**THE REGIONAL MUNICIPALITY OF YORK
ADDENDA # 5
T-19-16**

FOR: Construction of Paramedic Response Station No. 29 at 107 Glen Cameron Road in the City of Markham

ARCHITECTURAL ADDENDUM 03

York Region Paramedic Response Station #29
107 Glen Cameron Road, Markham

DWG TITLE: SITE AND GENERAL DETAILS

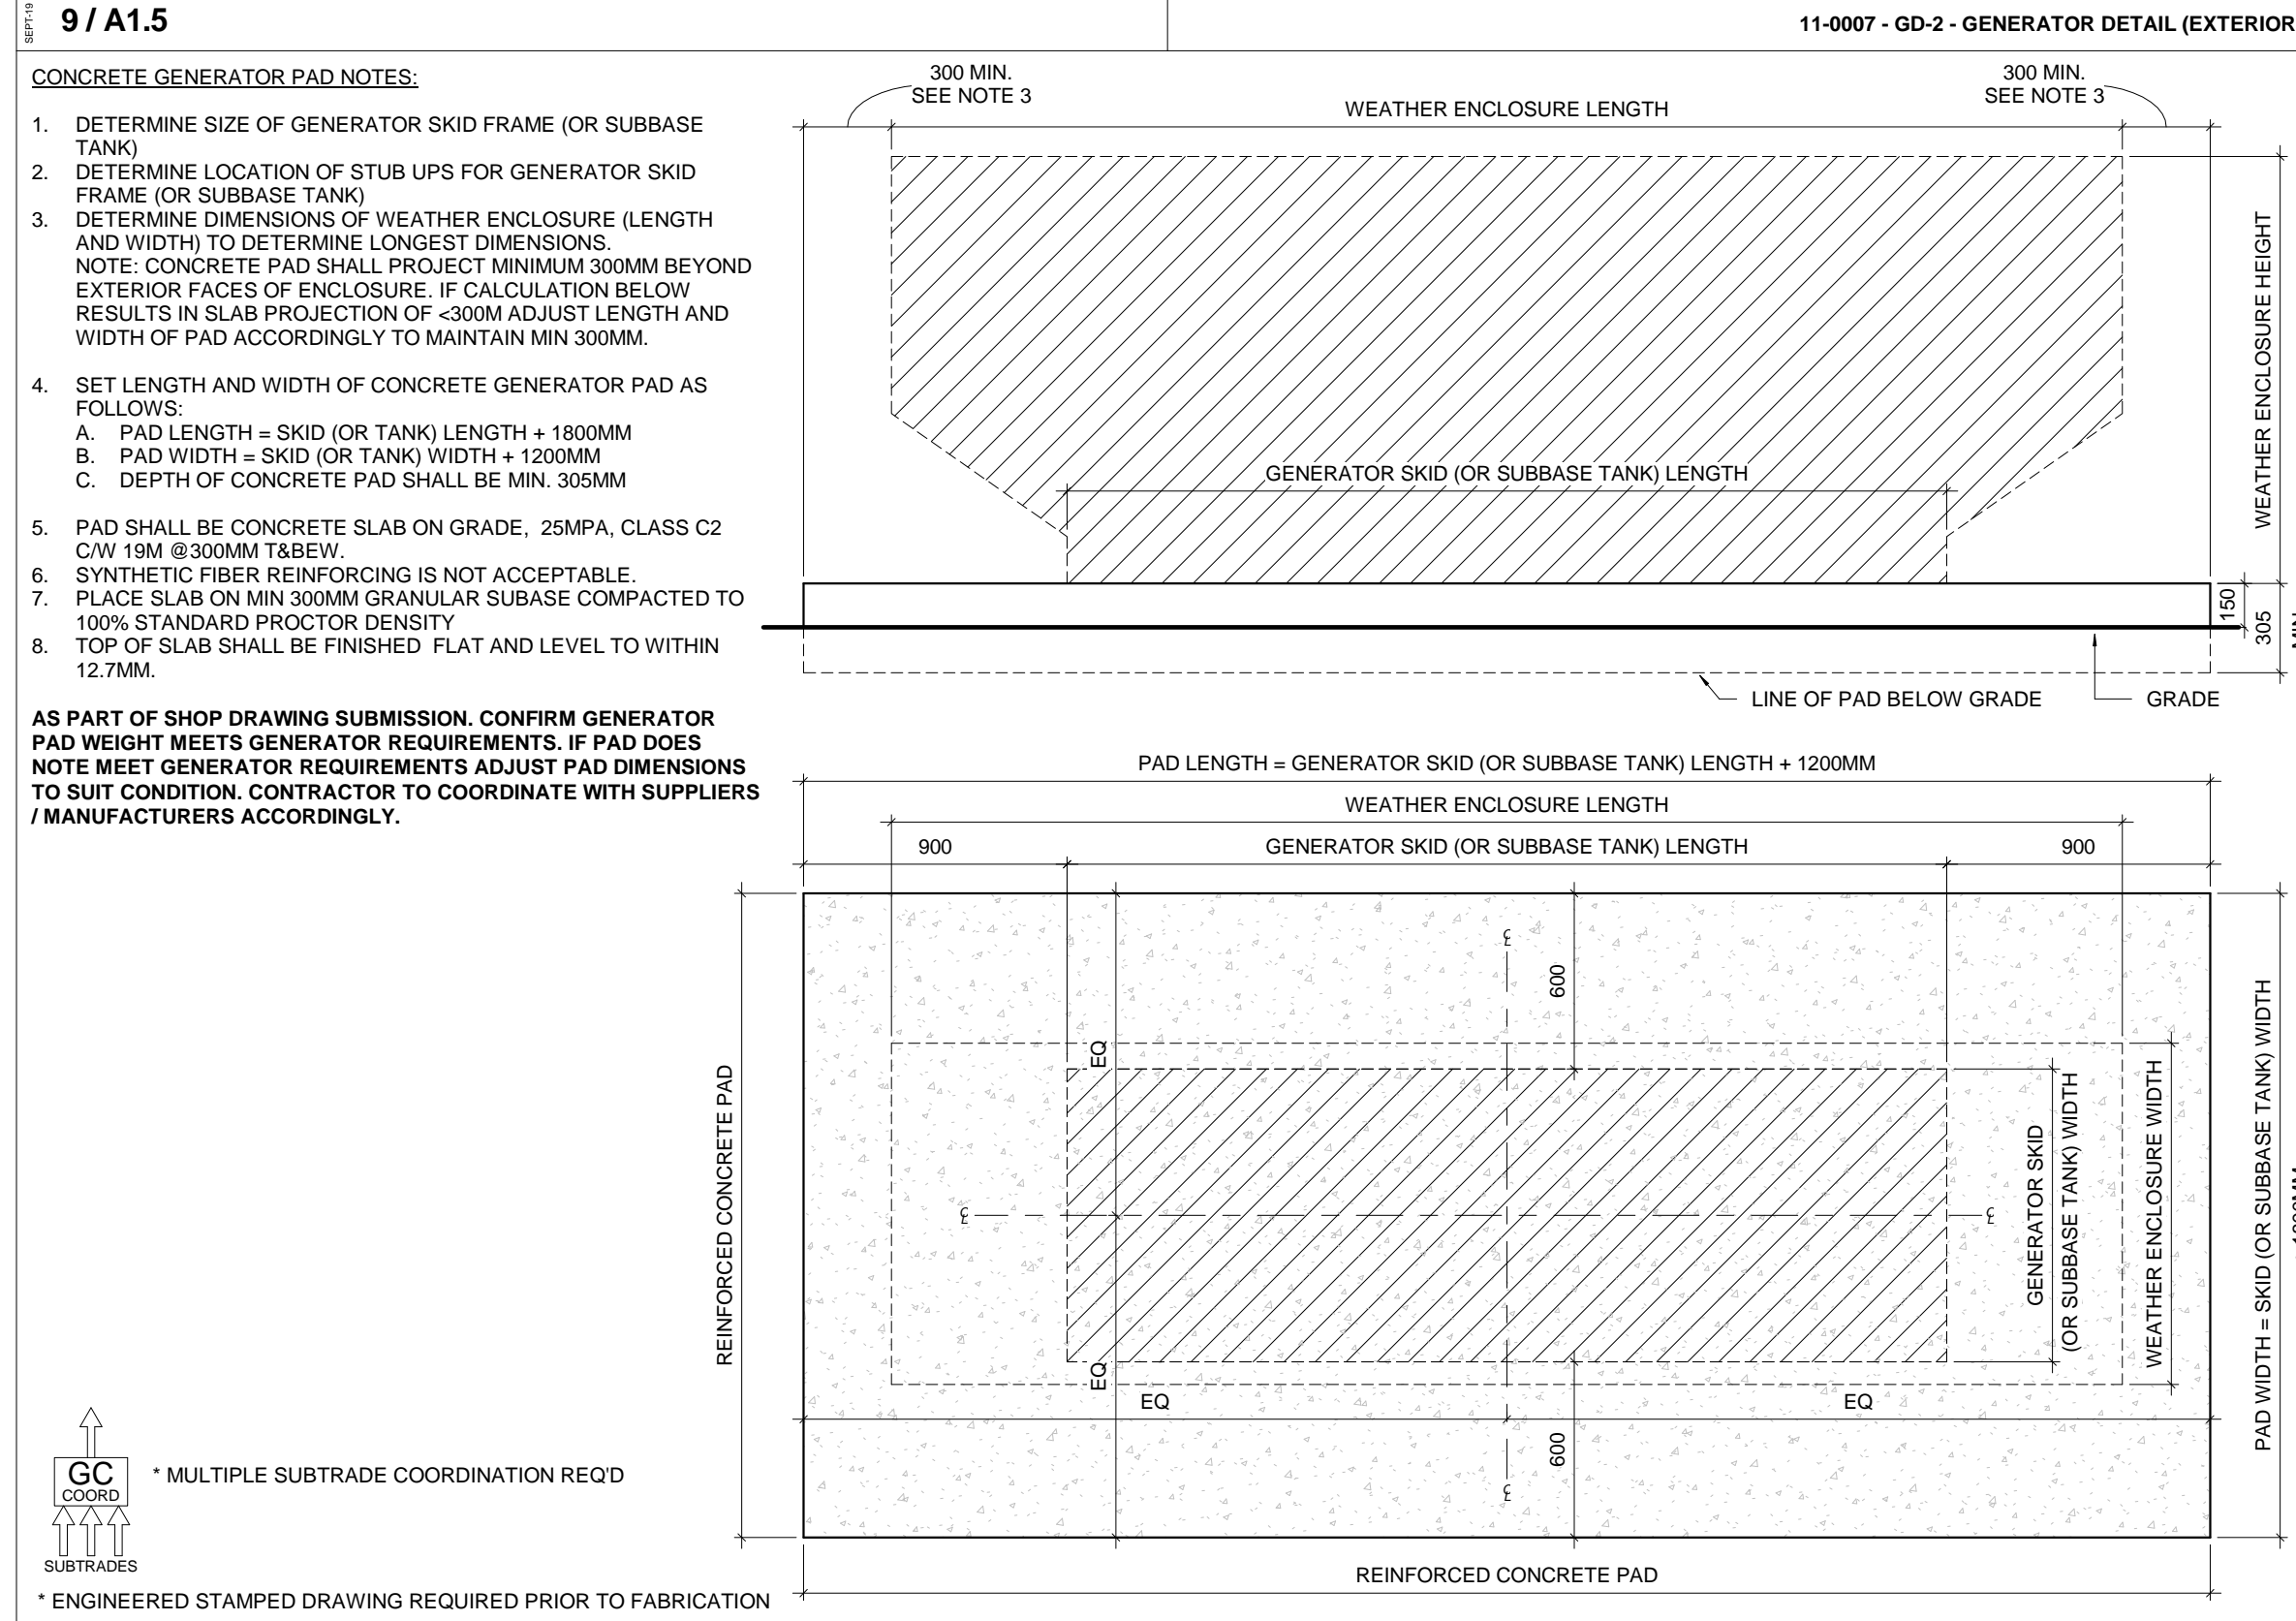
1. Refer to Drawing A1.5 Site and General Details

.1 Insert detail 9 Generator Detail. This detail replaces previous response in Addendum #2.

CONCRETE GENERATOR PAD NOTES:

- DETERMINE SIZE OF GENERATOR SKID FRAME (OR SUBBASE TANK)
- DETERMINE LOCATION OF STUB UPS FOR GENERATOR SKID FRAME (OR SUBBASE TANK)
- DETERMINE DIMENSIONS OF WEATHER ENCLOSURE (LENGTH AND WIDTH) TO DETERMINE LONGEST DIMENSIONS. NOTE: CONCRETE PAD SHALL PROJECT MINIMUM 300MM BEYOND EXTERIOR FACES OF ENCLOSURE. IF CALCULATION BELOW RESULTS IN SLAB PROJECTION OF $\leq 300\text{MM}$ ADJUST LENGTH AND WIDTH OF PAD ACCORDINGLY TO MAINTAIN MIN 300MM.

- SET LENGTH AND WIDTH OF CONCRETE GENERATOR PAD AS FOLLOWS:
A. PAD LENGTH = SKID (OR TANK) LENGTH + 1800MM
B. PAD WIDTH = SKID (OR TANK) WIDTH + 1200MM
C. DEPTH OF CONCRETE PAD SHALL BE MIN. 305MM

- PAD SHALL BE CONCRETE SLAB ON GRADE, 25MPa, CLASS C2 C/W 19M @ 300MM T&B.W.
- SYNTHETIC FIBER REINFORCING IS NOT ACCEPTABLE.
- PLACE SLAB ON MIN 300MM GRANULAR SUBBASE COMPACTED TO 100% STANDARD PROCTOR DENSITY

- TOP OF SLAB SHALL BE FINISHED FLAT AND LEVEL TO WITHIN 12.7MM.

AS PART OF SHOP DRAWING SUBMISSION, CONFIRM GENERATOR PAD WEIGHT MEETS GENERATOR REQUIREMENTS. IF PAD DOES NOT MEET GENERATOR REQUIREMENTS ADJUST PAD DIMENSIONS TO SUIT CONDITION. CONTRACTOR TO COORDINATE WITH SUPPLIERS / MANUFACTURERS ACCORDINGLY.
